**SUBJECT: TDCC Responses to NRC Comments on Final Status Survey Reports for Verification Areas VA-1 through VA-VI**

**NRC Comments and DOW Responses  
DOW Chemical Company's Bay City, MI  
Magnesium-Thorium Slag Storage Area  
Final Status Survey Reports for VA-I through VA-VI**

Figure 3-5  
Background Sample Locations

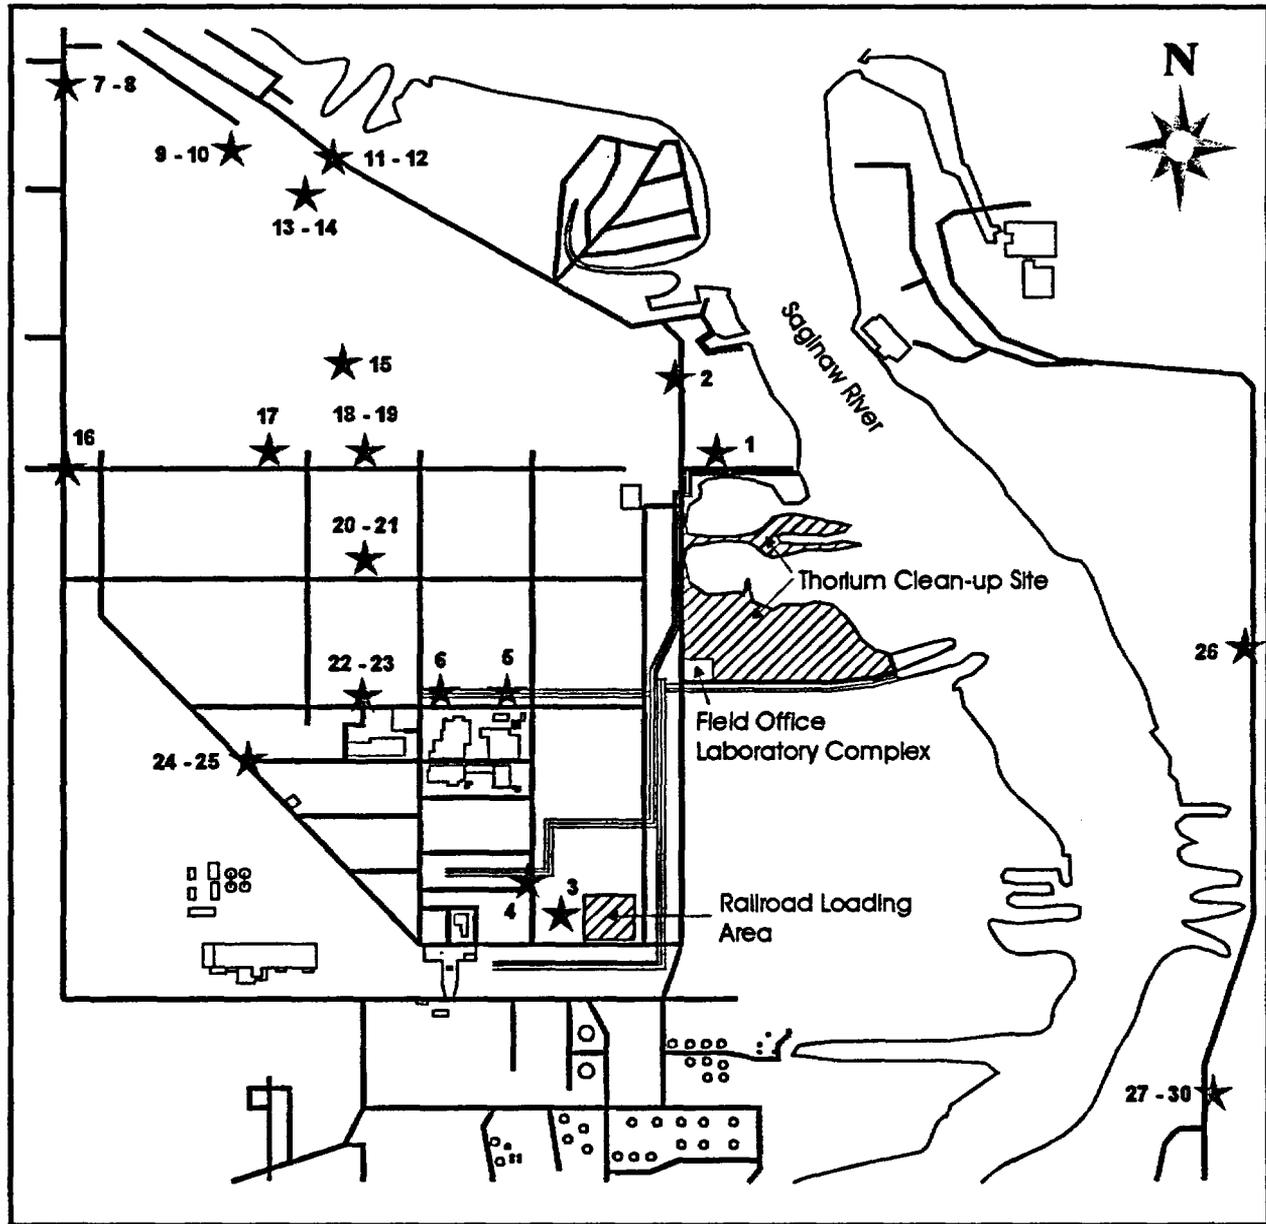
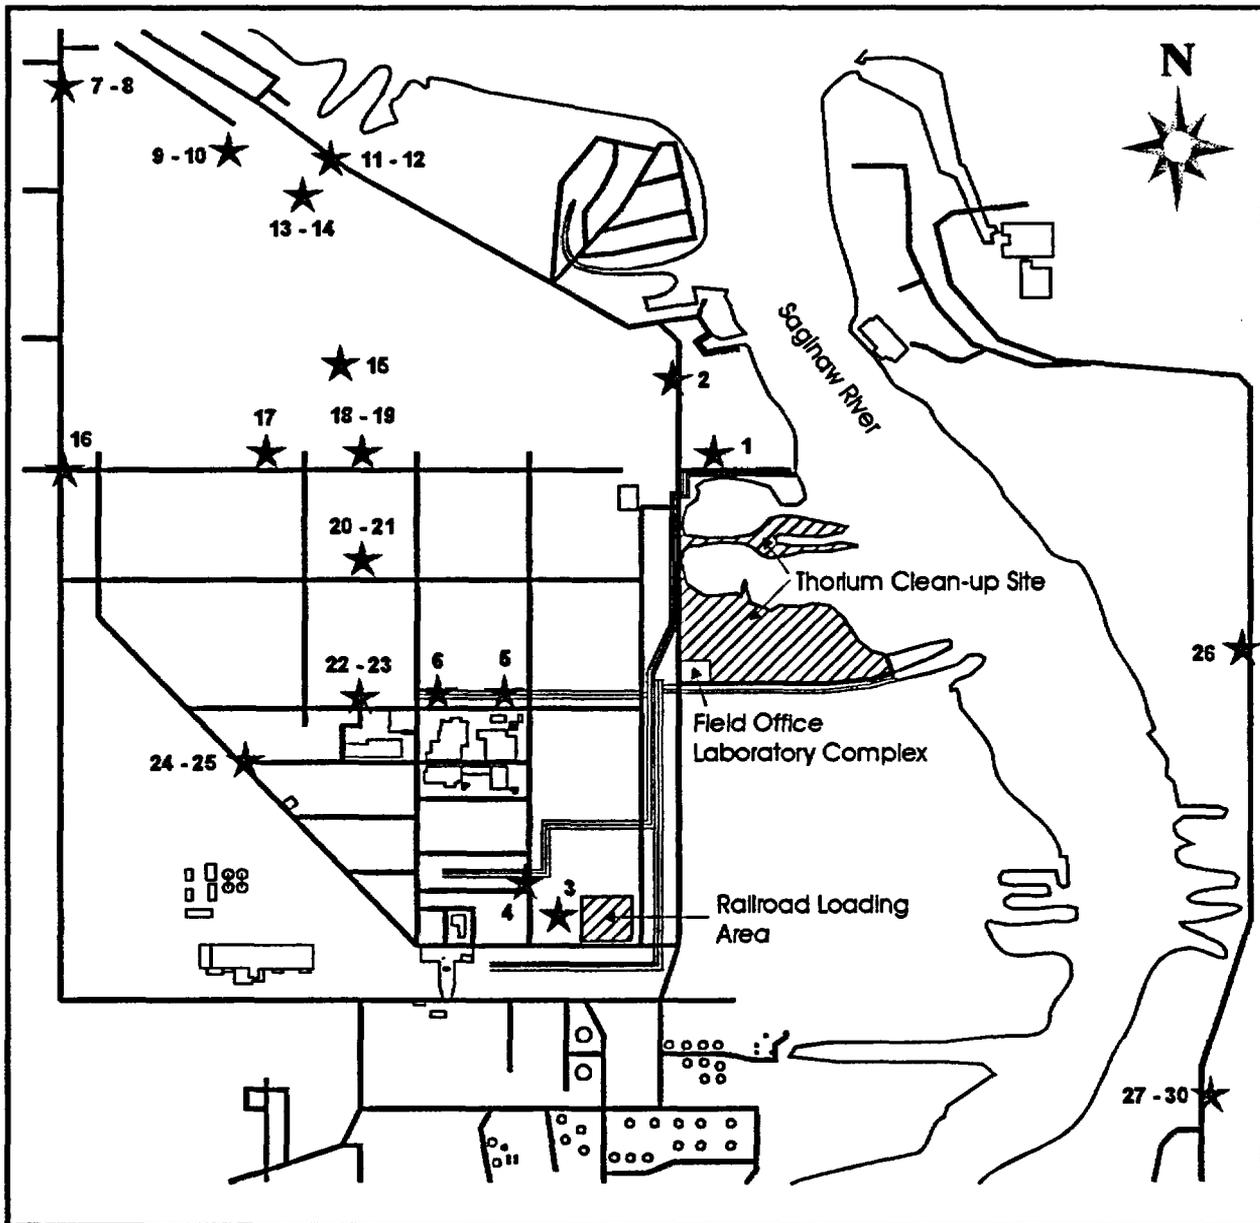
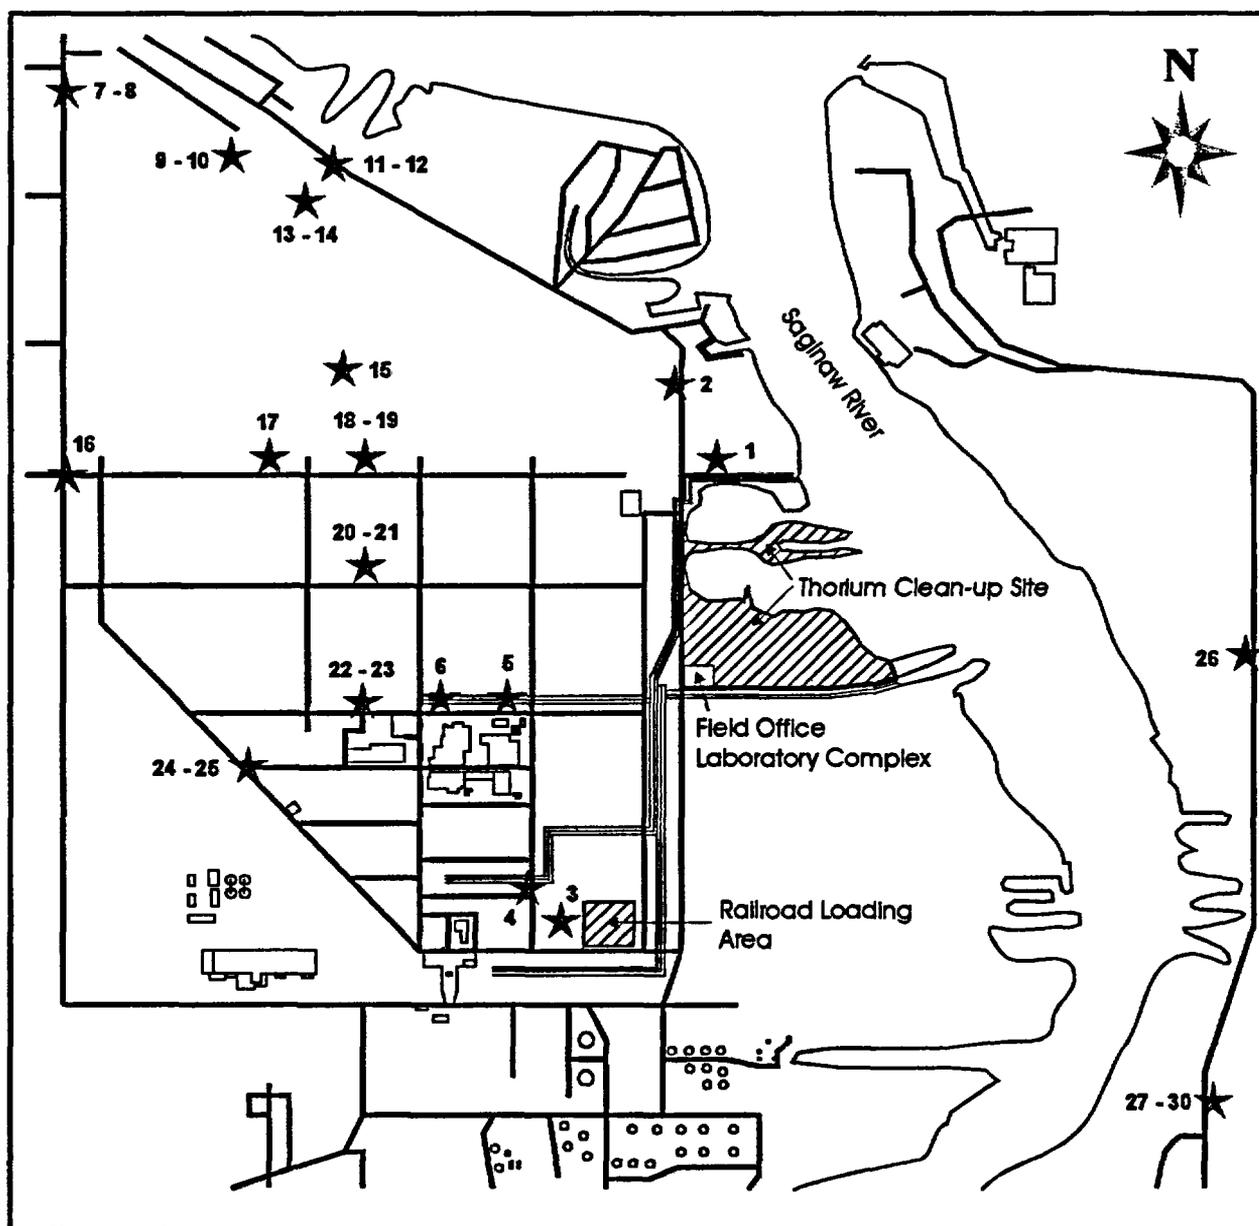
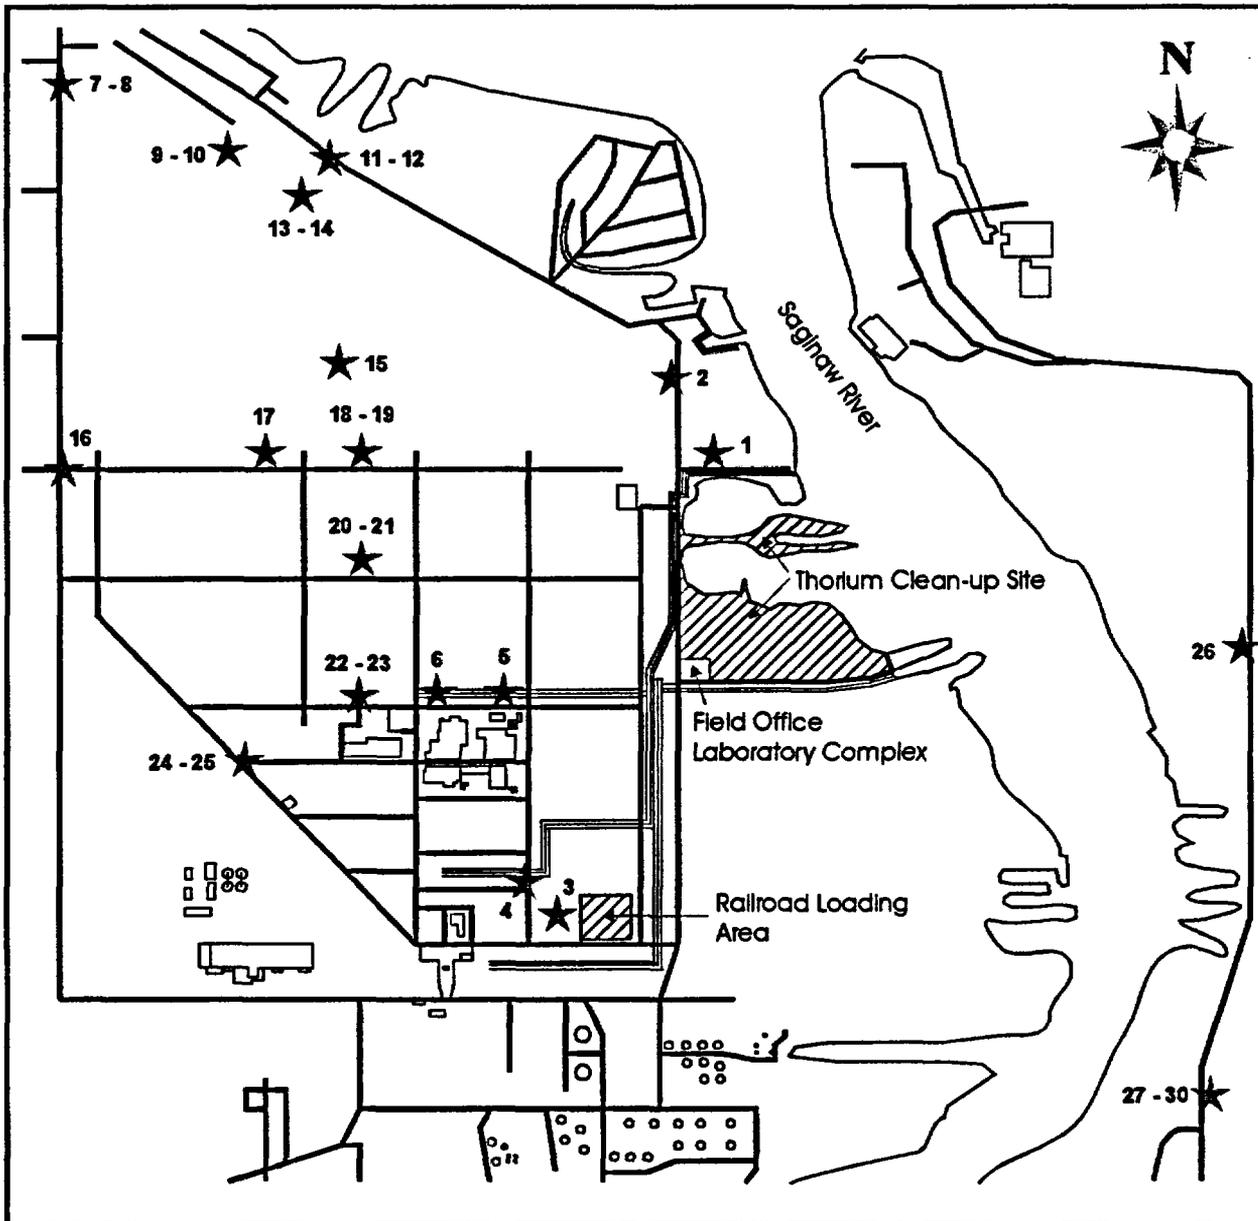
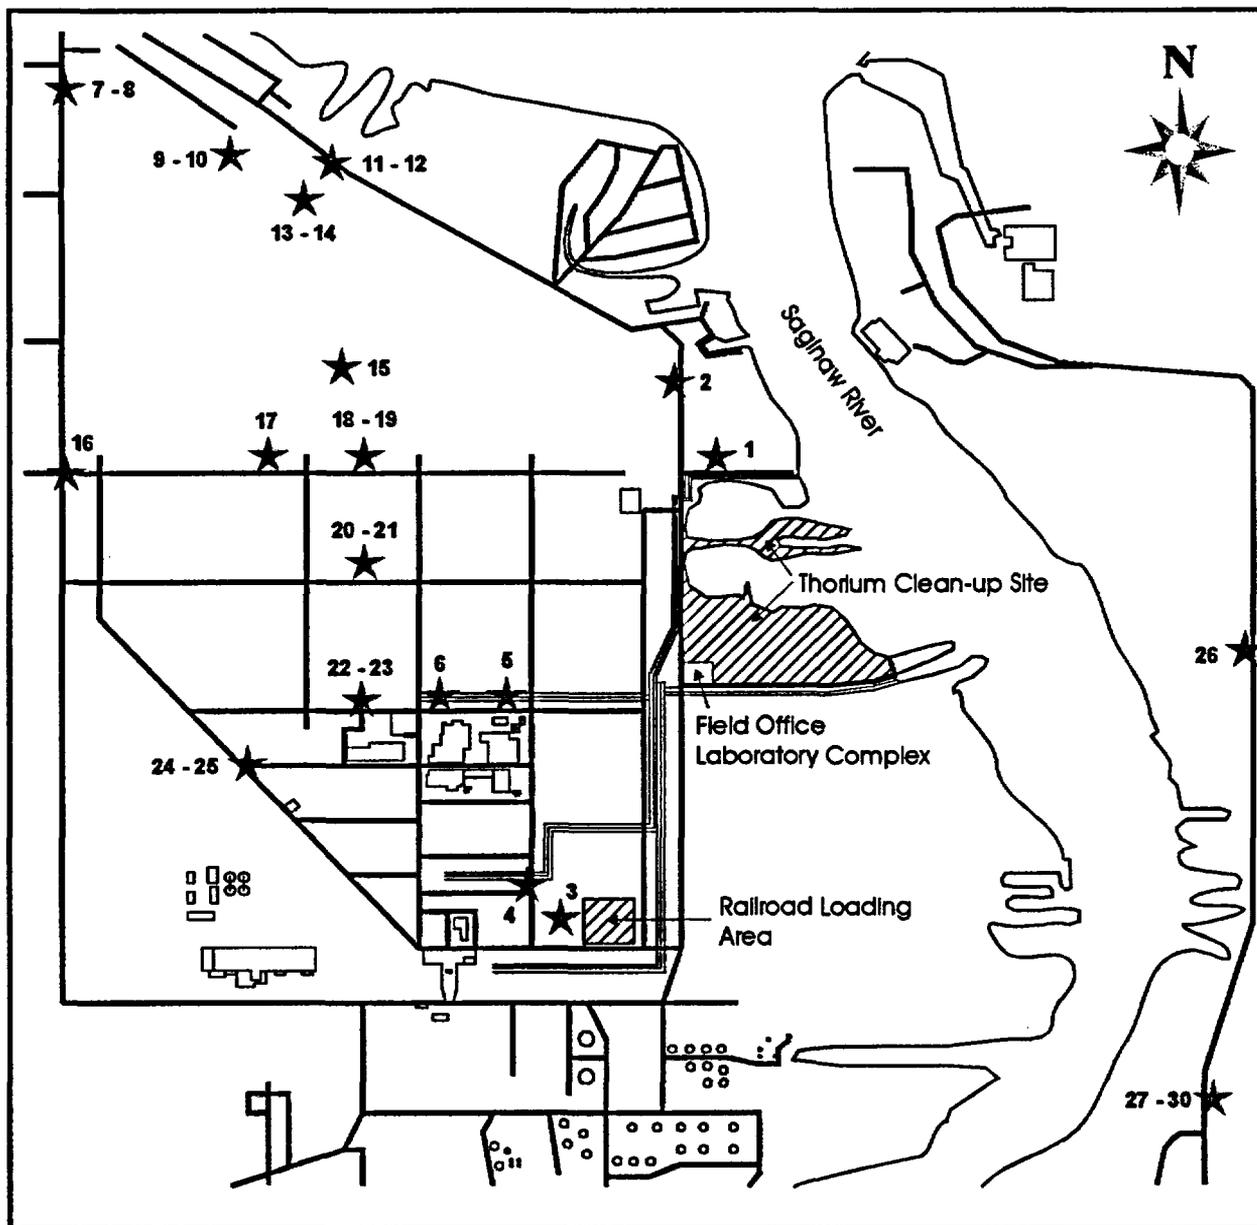
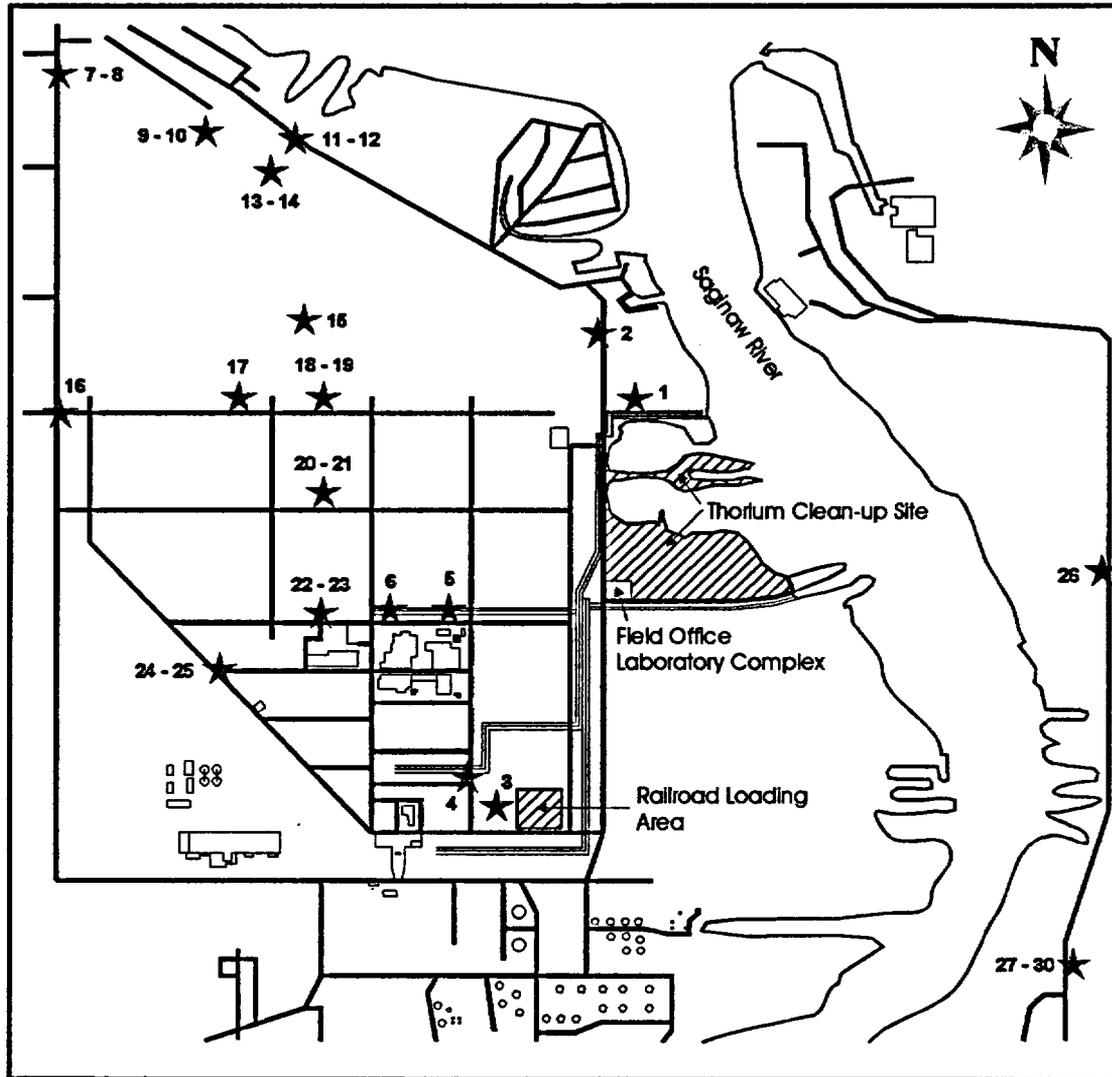
3. For Verification Areas VA-1 to VA-VI, the FSSRs explain that the 30 background soil sample locations are shown in the "background sample" figure. However, the figures show only background sample locations 1 through 25.

3. Figure 3-5, Background Sample Locations, has been revised and included in each of the FSSRs. The original map did show all 30 sample locations; however, it was unclear in that the five samples taken east of the site (across the river) were labeled as 1-5 instead of being correctly labeled as 26-30.
